UNITED STATES PATENT AND TRADEMARK OFFICE

APPLICATION NO.	FILING DATE	FIRST NAMED INVENTOR	ATTORNEY DOCKET NO.	CONFIRMATION NO.
10/099,775	03/15/2002	Jean-Christophe Jacques Kling	3206.2.1 NP	4985

Office Action Summary

DETAILED ACTION

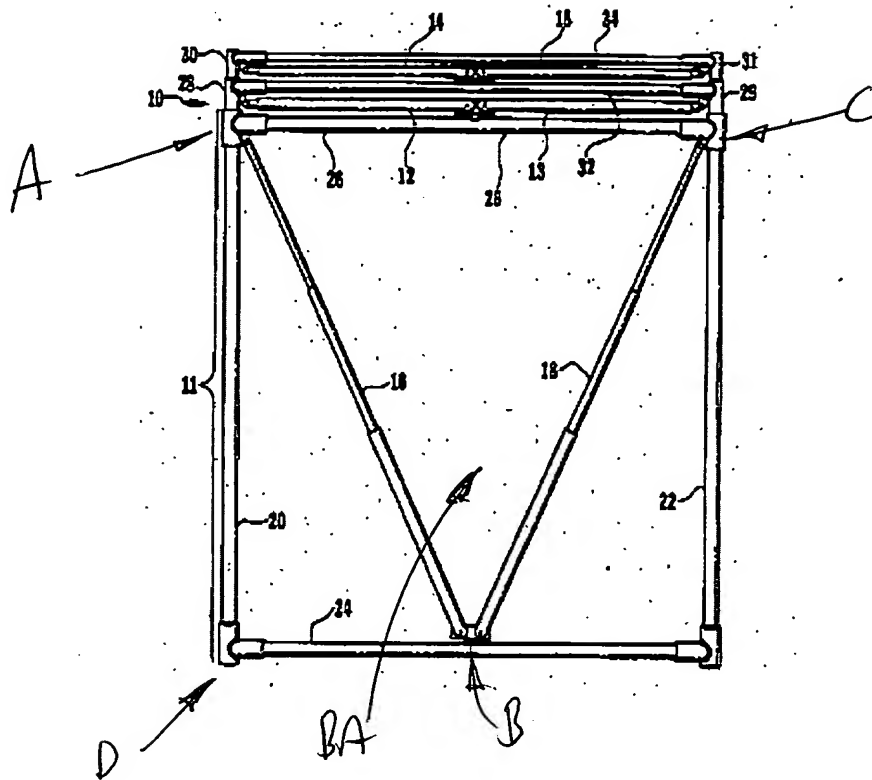
Claims 1-24 are rejected under 35 U.S.C. 103(a) as being unpatentable over US Patent #4,604,844 to MIKULAS, Jr. et al. MIKULAS, Jr. et al. discloses the use of an architectural system (10) including a triangular base (BA) consisting of a first (16), second (18) and third (26) strut aligned along first (AB), second (BC), and third (CA) axis; such that the first and third struts (16,26) form a first acute base angle (CAB), the first and second (16,18) struts form a second acute base angle (ABC), and the second and third struts (18,26) form a third acute base angle (BCA), see below; wherein the

struts (16,18) each consist of at least two rigid pieces (column 2, line 67 to column 3, line 2) movable apart to form a strut elongation. The structure (10) further includes a first node (A) engaging the first (16) and third (26) struts, a second node (B) engaging the first (16) and second (18) struts, a third node (C) engaging the second (18) and third (26) struts, and an extension (20,22,24) (28,30) and (29,31); wherein the extensions (20,22,24) (28,30) and (29,31) consists of fourth struts that engage the triangular base (BA), see the marked attachment. MIKULAS, Jr. et al. discloses the basic claimed structure except for explicitly detailing the exact dimensions of the angles forming the base triangle or the angle of the fourth strut. Although MIKULAS, Jr. et al. does not detail explicit angles that form the base triangle, it would have been obvious to one having ordinary skill in the art at the time the art was made to select an angle dimension

suitable for the use intended as an obvious matter of design choice. For instance, larger width structures a larger angle dimension would be required; however, when a smaller size structure is being formed, a smaller angle dimension would be required. Also, the strength of the member forming the strut or how the structure is intended to be used will determine the size of the angles that form the triangular base. In reference to claims 2-4, the fourth axis (DA) forms an angle (DAB) with the first axis; however, selection of the angle between the first and fourth axis or the angle of the fourth axis is also a matter of design choice, see also the marked attachment. Further, the applicant discloses a wide range of angle dimensions suitable for selection of the angle between the first and fourth axis, thus the applicant has shown no criticality for the selection of any one desired angle dimension. Regarding claims 5 and 11, MIKULAS, Jr. et al. also does not disclose a strut diameter or node radius; however, this too is a matter of design choice dependent upon the use intended. In reference to claim 6, the extensions include polygons (14,15,34); (12,13,32); (28,12,26); (30,32,14); (29,26,13) and (31,32,15) having "N" number of sides each occupied by a respective strut such that the third axis (CA) contains one of the "N" sides (26), the fourth axis contains another of the "N" sides (20) wherein the fourth strut forms a portion of the polygon. Regarding claims 7-10 and 14-24, the values for "j"; "n"; "m"; "t"; "q"; or "k"; are also a matter of design choice dependent upon the use intended.

Applicant's arguments filed 8/10/05 have been fully considered but they are not persuasive. Regarding the applicant's argument that MIKULAS does not teach an extension forming an angle greater than three degrees; clearly the extension formed by (20,22,24) is positioned at an angle greater than three degrees of the base triangles. This extension formed by (20,22,24) extends by at least a ninety degree angle, as does the extensions (28,30) and (29,31).
